LAND USE APPLICATION - COMPLETENESS REVIEW

Subject Property:	676 17 th Street SE
Reference Number:	24-103565-PLN
Application Type:	Class 3 Site Plan Review and Class 1 Design Review
Date Application Accepted:	February 7, 2024
Applicant:	Servando Garcia S & V Garcia Investments LLC PO Box 21444 8135 River Road NE Keizer, OR 97307-1444 estimating@sunsetstuccollc.com
Contact:	Ronald Ped 6850 Burnett Street SE Salem, OR 97317 rjp@rktect.com

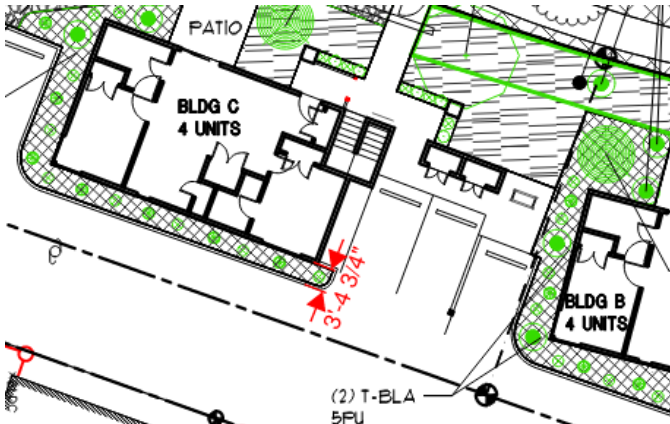
702.015(d)(1) – Parking and Site Design Standards
Not addressed.
Proposed configuration does not comply, an Adjustment to this standard will not be supported.

See included plan markup.

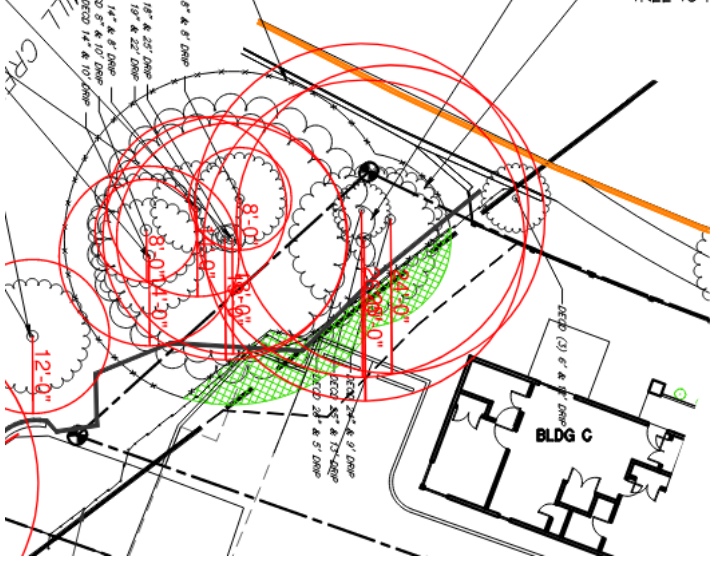
Off-street parking spaces are proposed between the ground level of the northern most building and Oak Street SE. Please adjust the orientation of the building and parking so parking spaces are not proposed between the ground floor and abutting street.

Parking spaces are provided on the under the upper floors of the building, however there is no

screening wall provided to obstruct view of the parking area.	
702.015(d)(2) – Parking and Site Design Standards Okay	To ensure safe pedestrian access to and throughout a development site, pedestrian pathways shall be provided that connect to and between buildings, common open space, and parking areas, and that connect the development to the public sidewalks. Pedestrian pathways shall be a minimum of five feet in width. A pedestrian pathway connection to the southern most parking spaces and solid waste service area is required.	
Chapter 800 – General Development Standards
